2101 N. Rampart St
Loretta's Pralines

CONDITIONS SHEET
Historic Preservation Certification Application

Extension to 42 inches of 36 inch wrought or cast iron handrail:

GUARDRAIL MODIFICATION
FOR LIFE SAFETY COMPLIANCE &
LATERAL SUPPORT

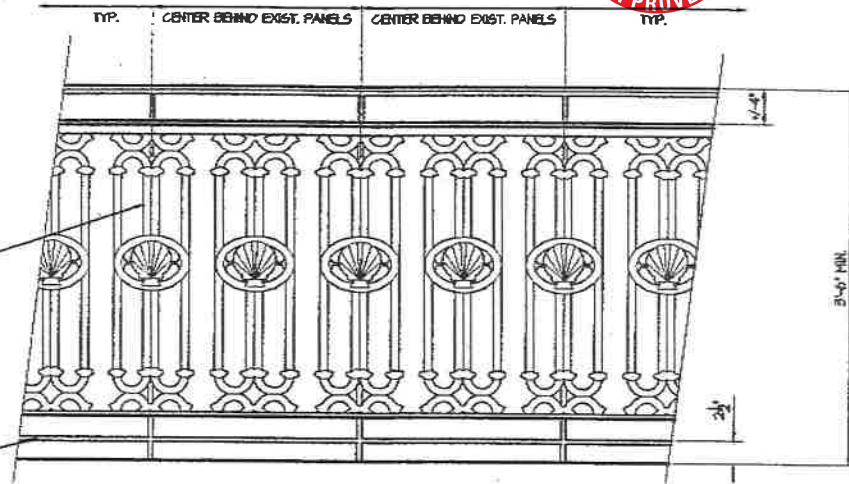
RAILINGS TO BE
MODIFIED TO BE 42"
AS SHOWN

RAILINGS TO BE
MODIFIED TO BE 42"
AS SHOWN

NEW TOP RAIL, GALVANNEUM
1/2" SQUARE STEEL BAR WITH CAP RAIL TO MATCH EXISTING. ALIGN VERTICAL SUPPORTS AS SHOWN. SECURE TO BACK OF EXISTING WITH 1/2" BAR AT TOP AND BOTTOM RAILS. SECURE TO DECK WITH 3/4" GALV. SCREWS THRU 1/4" BOTTOM PLATE (TYP)

EXISTING HANDRAIL:
REPAIR BROKEN CAST PANELS AS REQUIRED BY GILD WELD. REPAIR STEEL COMPONENTS AS REQUIRED BY ARC WELD OR MECHANICAL FASTENERS TO MATCH EXISTING CONNECTIONS.

NEW BOTTOM RAIL (CONTINUOUS)
